Contract #: 04-0120F4Cty: SF/ALA Rte: 80 PM: 13.2/13.9File #: 69.25B**QUALITY ASSURANCE -- NON-CONFORMANCE REPORT****Location:** Changxing Island, Shanghai, P.R. China**Report No:** NCR-000243**Prime Contractor:** American Bridge/Fluor Enterprises, a JV**Date:** 26-Feb-2009**Submitting Contractor:** Zhenhua Port Machinery Company, Ltd (ZPMC), Changxing Island**NCR #:** ZPMC-0217**Type of problem:**

Reference Description: Grinding of FB063-002 rib stiffener (RS) cutouts**Description of Non-Conformance:**

Dear: Mr. Charles Kanapicki
Attention: Mr. Thomas Nilsson Project Manager - OBG
Subject: NCR No. ZPMC-0217

Subject: Fabrication Issue: Misalignment between Plate Stiffeners and FB Web Slots in SEG1AW	
References:	
Sub/Sup: ZPM	Sub RFI #: RFI-ZPM-000726R00
Response Required by: 02-September-2009	Response affects critical path activity? Yes

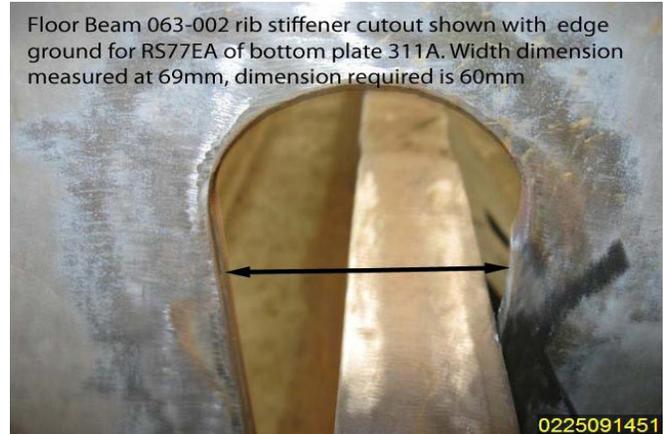
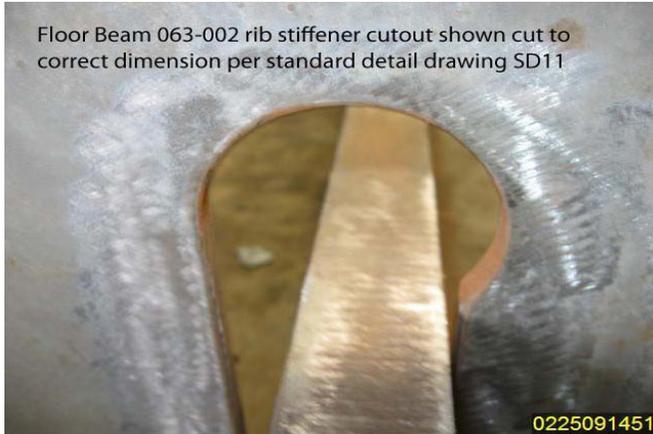
Caltrans Quality Assurance (QA) Inspector observed non-conformance on five floor beam cutouts for the bottom plate rib stiffeners (RS). These cutouts had been ground on one side to facilitate the fit-up with the RS. The approved shop drawing indicates that the floor beam cutout has a width of 60mm. ZPMC ground these cutouts to the following dimensions:

For bottom plate 309A:

RS77E cutout width: 68mm

RS78E cutout width: 66mm

For bottom plate 311A:

RS77EA cutout width: 69mm

RS87GA cutout width: 65mm

RS85C cutout width: 65mm

The fabrication of the floor beam cutouts for RS in segment 1AW is not according to the approved shop drawing.

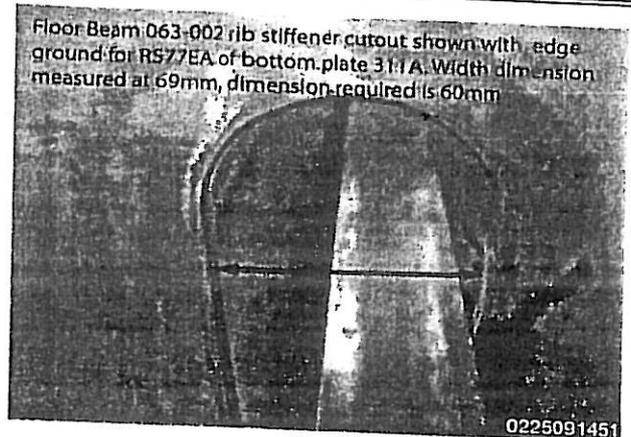
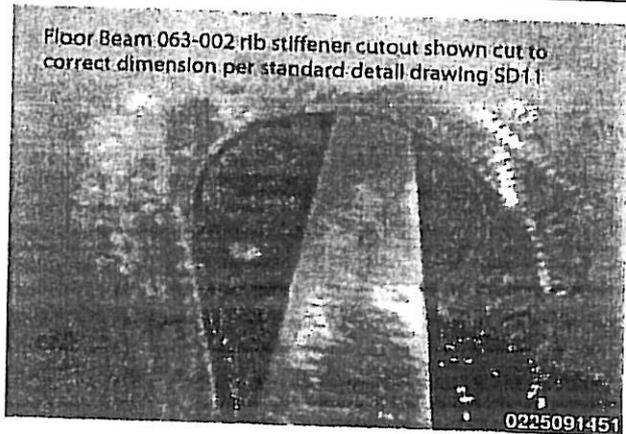
Caltrans Quality Assurance (QA) Inspector observed non-conformance on five floor beam cutouts for the bottom plate rib stiffeners (RS). These cutouts had been ground on one side to facilitate the fit-up with the RS. The approved shop drawing indicates that the floor beam cutout has a width of 60mm. ZPMC ground these cutouts to the following dimensions:

For bottom plate 309A:

RS77E cutout width: 68mm

RS78E cutout width: 66mm

For bottom plate 311A:

RS77EA cutout width: 69mm

RS87GA cutout width: 65mm

RS85C cutout width: 65mm

The fabrication of the floor beam cutouts for RS in segment IAW is not according to the approved shop drawing.

Draft of Welding Discontinuity:

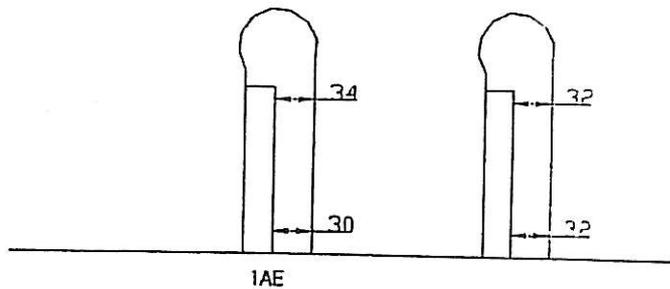
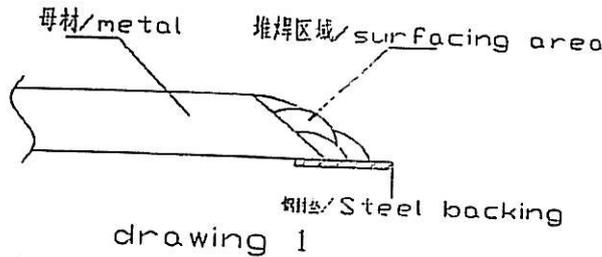
1AE and 1AW box, the size between floor beam weld through hole and I-rib wasn't according to drawing requirement, 1AE(PP9) two position, 1AW (PP9) one position, it shall be 25mm according to drawing requirement, see the following draft.

Weld distortion and fabricate error.

1. QC and CWI should be present to witness the repair.
2. Grind the repairing area cleanly;
3. Prepare an right joint according to the approved WPS;
4. Perform 100%VT ^{± MT} to ensure no defects exist, and add steel backing before welding.
5. Preheat and weld according to the relevant WPS; and weld the unacceptable through holes to meet the requirement of work drawing;
6. Gouge off the steel backing after welding and then grind the weld flush with base metal.
7. Perform VT and MT ^{BOTH SIDES & WELD FRONT} inspection to the repaired area.
